ARCHITECTURE PLANNING URBAN DESIGN

May 14, 2020

RE: 15925 Quail Hill Road

Front and Left Side View

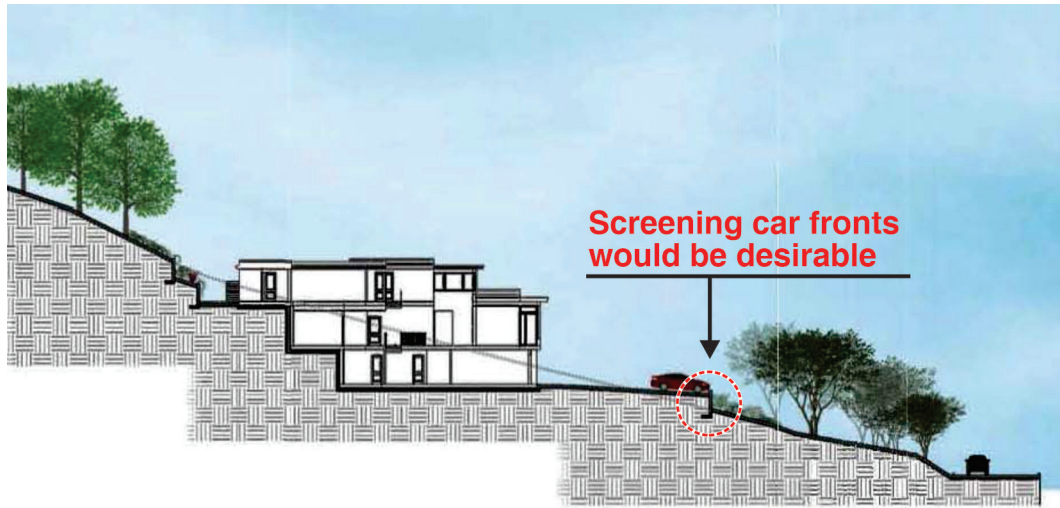
Note: Low wall at bottom is different than shown on the floor plans

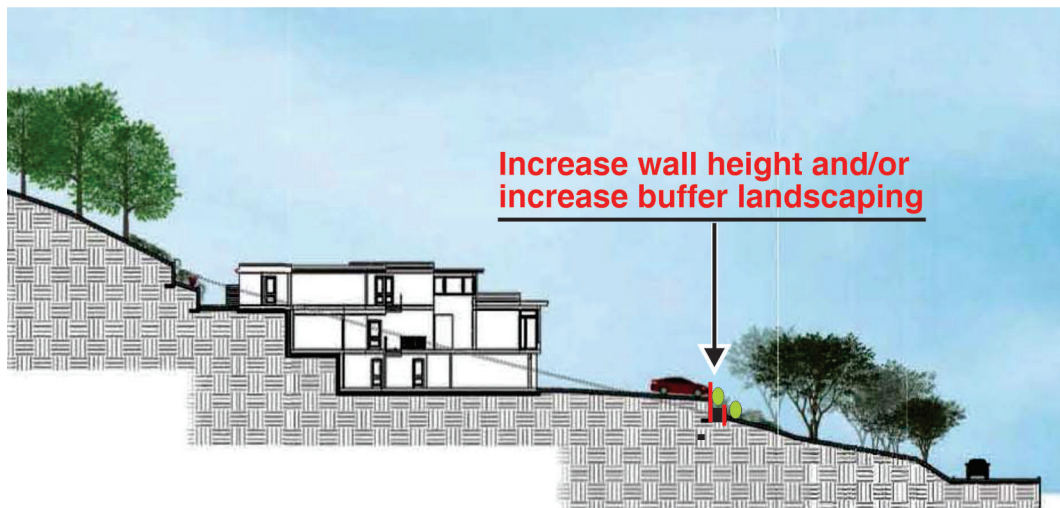
1. The low stone wall at the exterior parking area has proposed landscaping in front of it, but the plantings may not shield the car fronts from view.

Recommendation: Increase wall height and/or increase buffer landscaping.

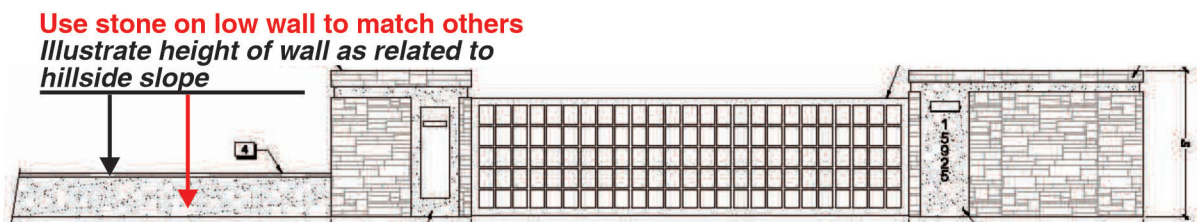
2. While most of the low walls are faced with stone, the low wall along Drysdale Drive is proposed as stucco with a stone cap.

Recommendation: Use stone to match other low landscape walls, and provide an illustration to show the proposed wall heights related to the hillside slope (e.g., sloped or stepped).

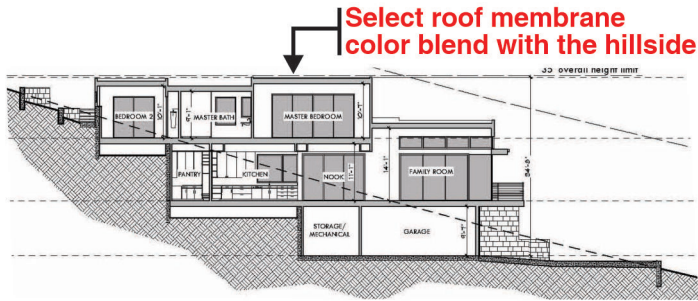
3. All roofs are relatively flat with PVC roofing which will present a large viewable area from above.

Recommendation: Select roofing color to blend with the home colors and the natural environment.

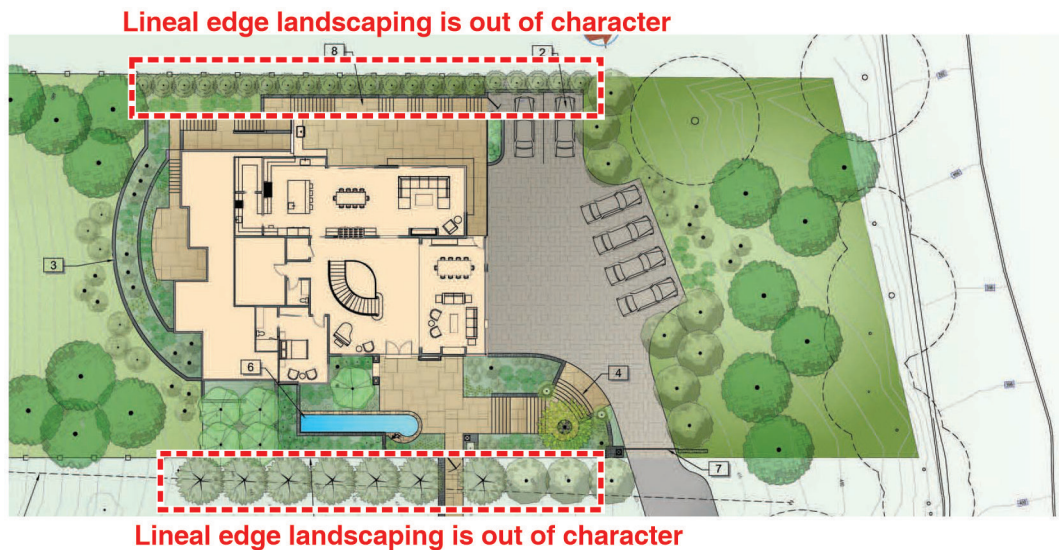
4. In general, the landscaping is varied in size and placement, and is designed to blend with the hillside environment as required by the Town's *Hillside Development Standards and Design Guidelines*. However, the proposed landscaping at both side setbacks is more regular and linear - see example photos below.

Recommendation: Reevaluate the side yards landscaping to increase its informality consistent with the hillside location.
